**VENTURA UNIFIED SCHOOL DISTRICT
ELMHURST ELEMENTARY SCHOOL HVAC REPLACEMENT**

ADDENDUM #01

ADDENDUM NUMBER ONE

**E1-24 ELMHURST HVAC**

2 REFLECTED CEILING PLAN - BLDG. AD
SCALE : 1/8" = 1'-0"

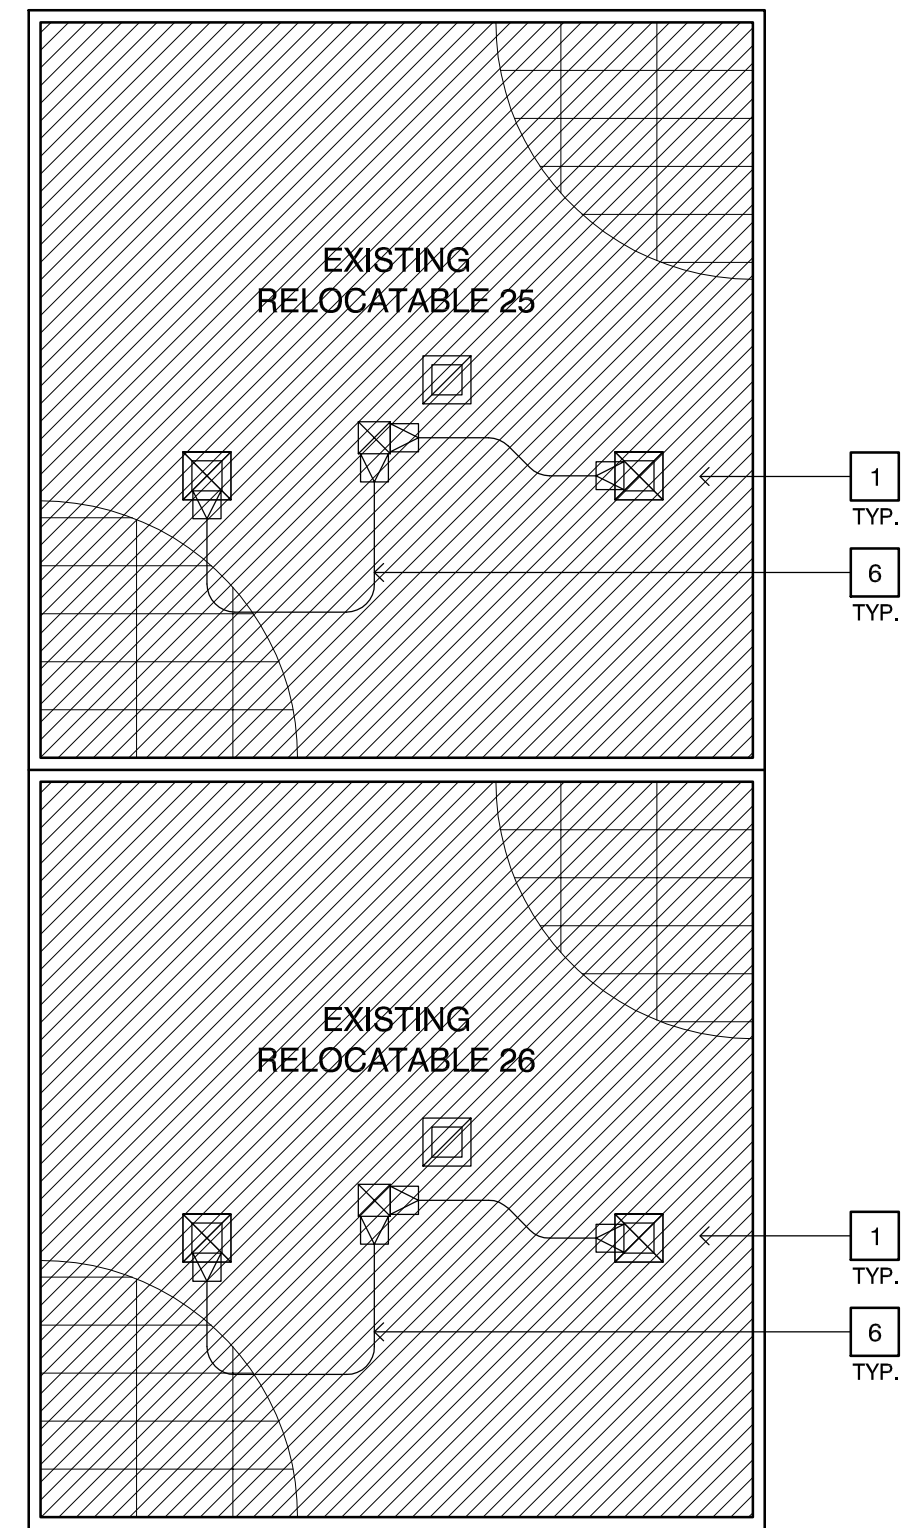
Insert two new drawing sheets A-600 and A-601 to the bid plans. These new reflected ceiling plans indicate extent of planned ceiling modifications and replacements.

1 SITE POWER PLAN
SCALE: 1"=20'-0"

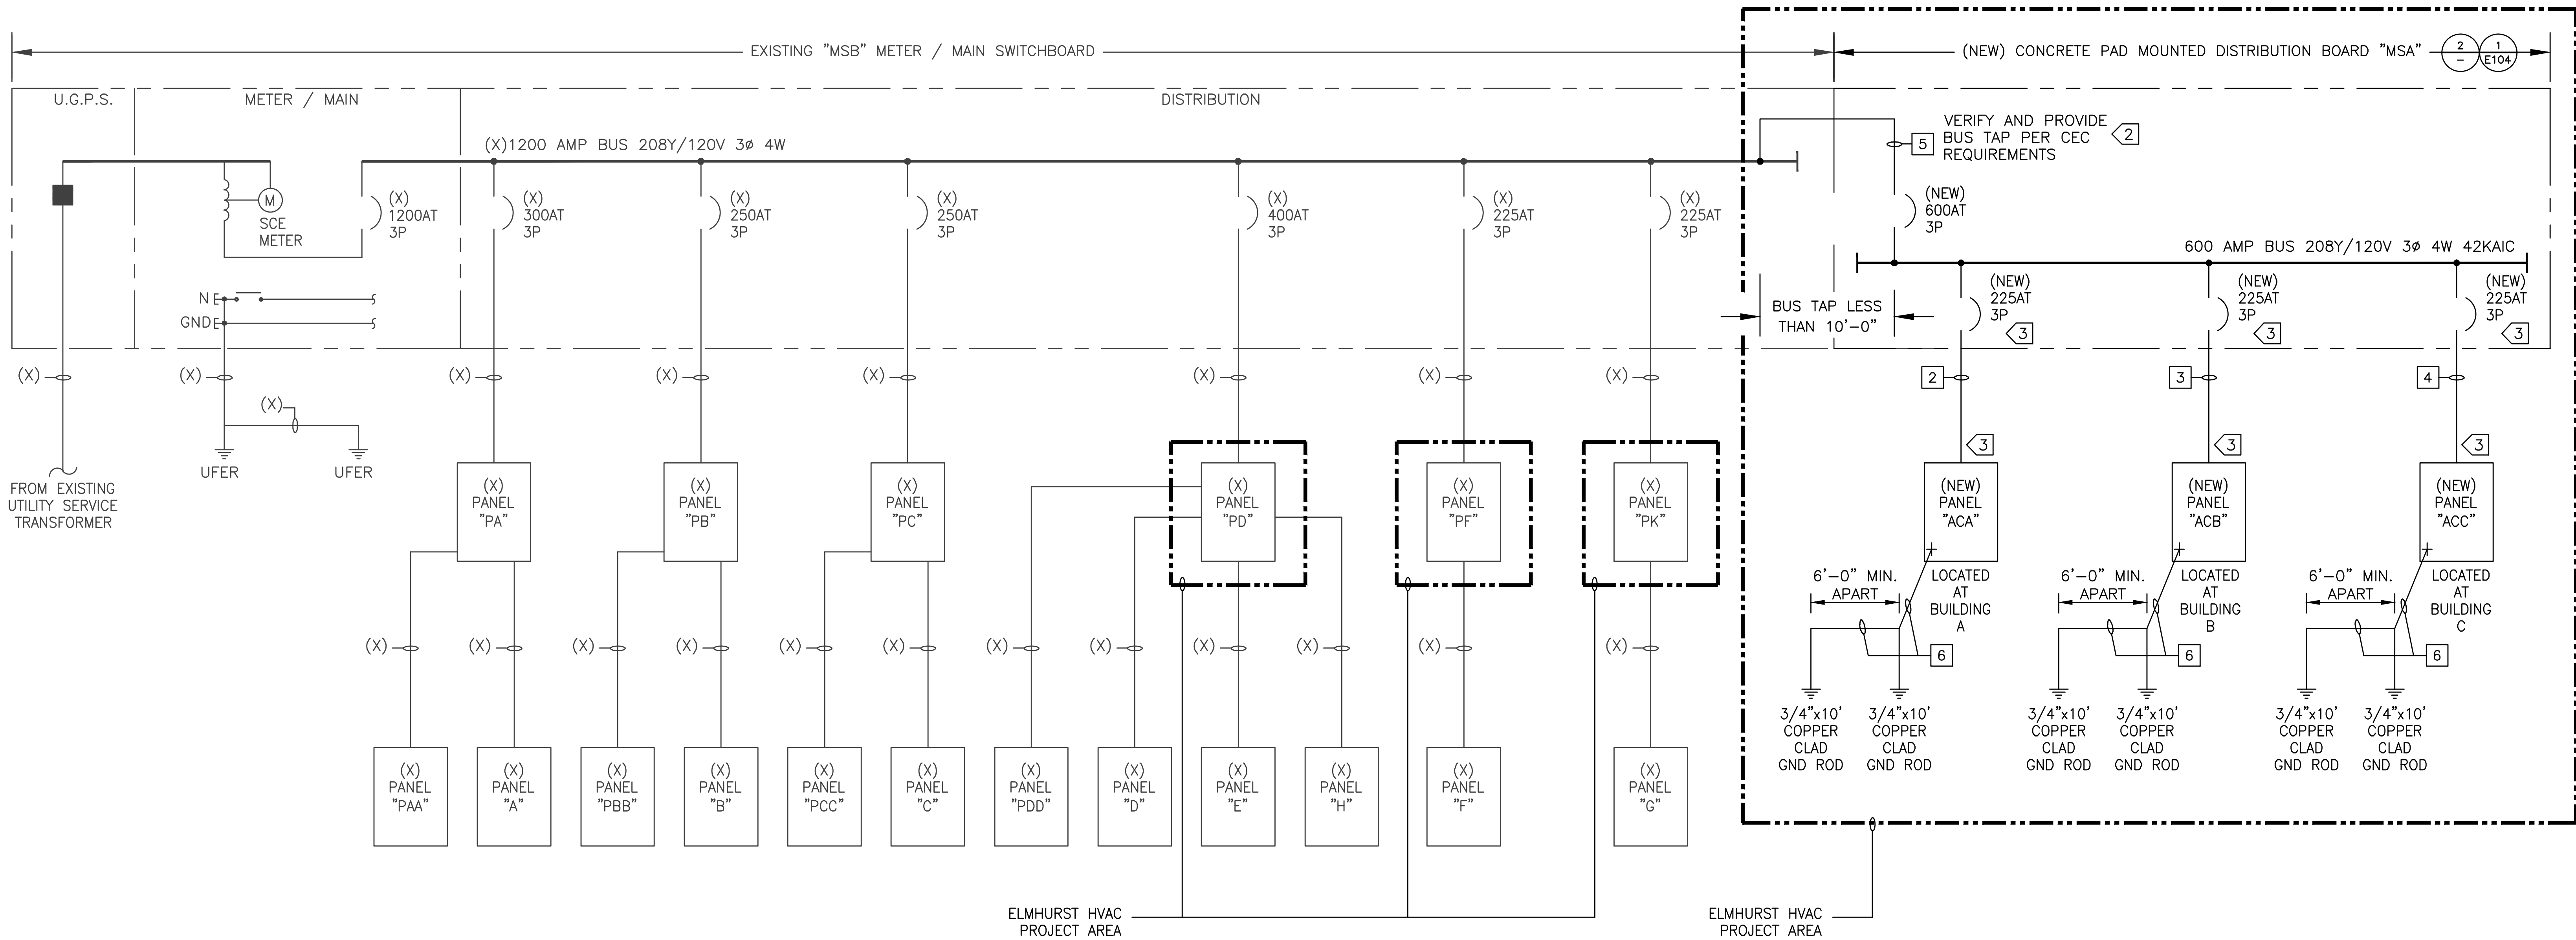
See attached revised sheets E102 and E103 for revised site power information.
